UDRP Report

110, 116 York Street

RE: Response to UDRP Recommendations – April 4, 2025
110, 116 York Street

Urban Design Brief
April 4, 2025

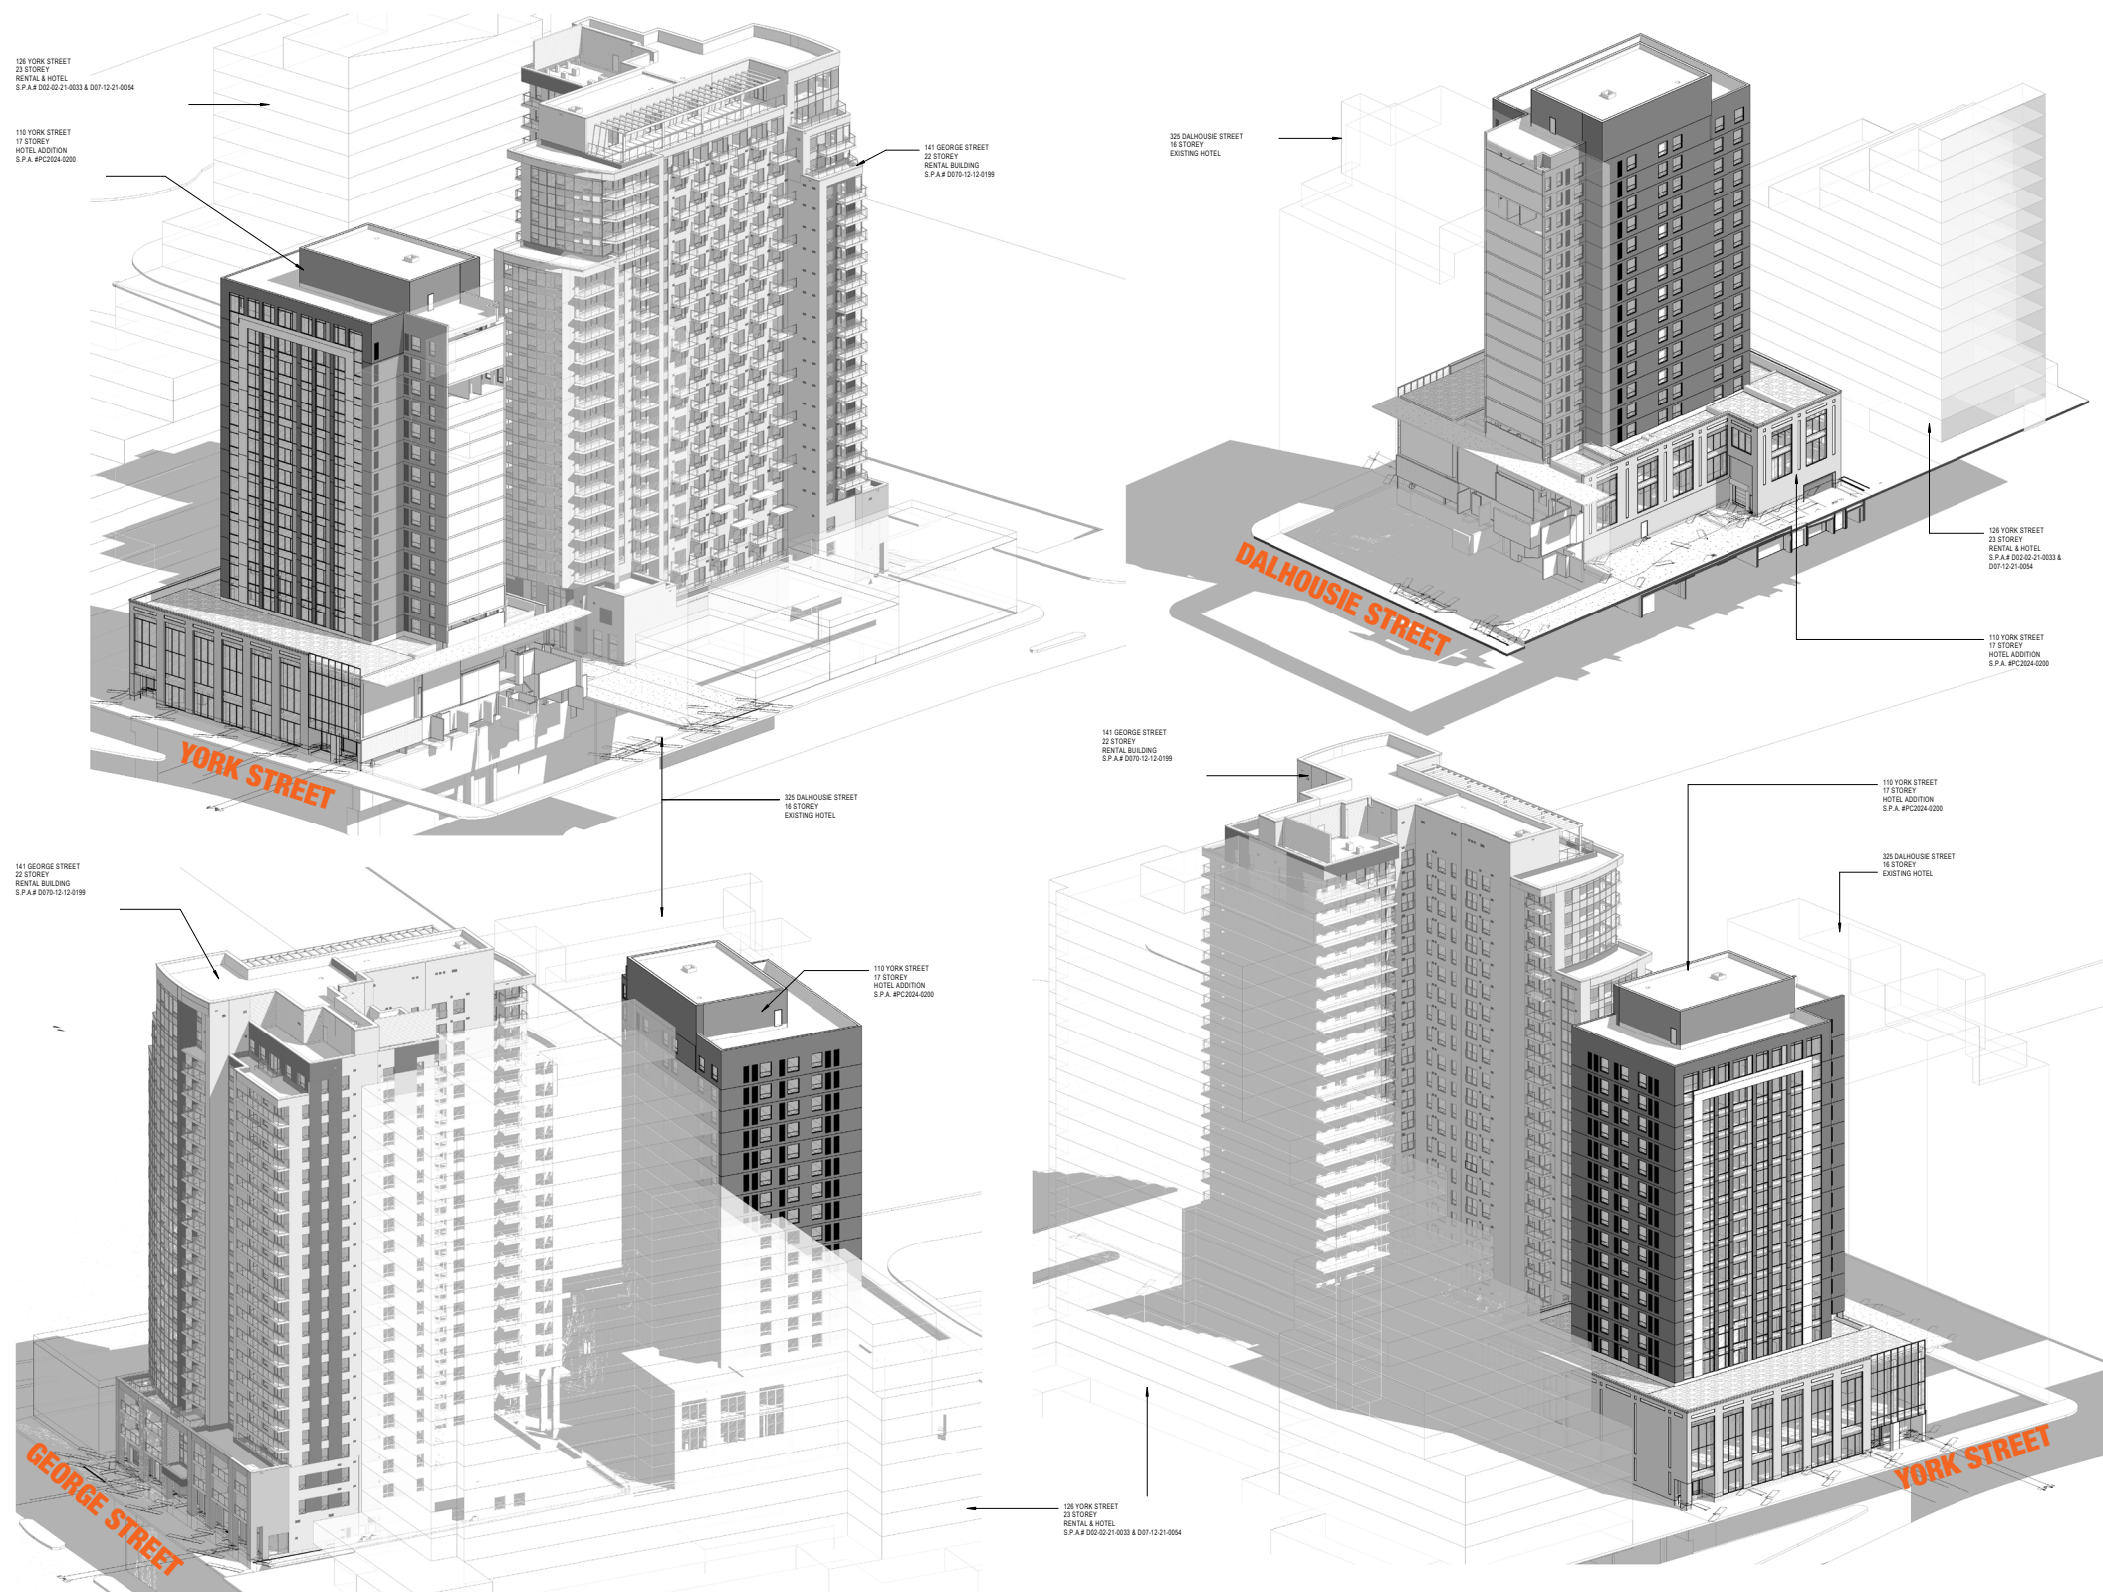
City Comment 22: The following element of the preliminary design are of concern:

- a. Active frontage facing York Street.
- b. Blank wall facing east should consider quality materials showing sensitivity to the heritage nature of the ByWard market and the neighbouring development.
- c. Tower floor plate size. Why are the towers connected? Is this the best approach? Shadow impacts will be reviewed.

- a. **Design proposes significant transparency of the active frontage on York Street, in line with ByWard market policy, creating foot traffic east of the district.**
- b. **The material and fenestration of the east façade of the development is proposed to be a continuation of the north façade, considering the use of the podium. There is potential for a mural on the east façade, which may incorporate references to the heritage of the area.**
- c. **The proposed development is an extension of the Andaz Hotel and some connections between the buildings will be provided. A stairwell will connect the main lobby of the existing Andaz Hotel to the second storey of the proposed hotel extension.**
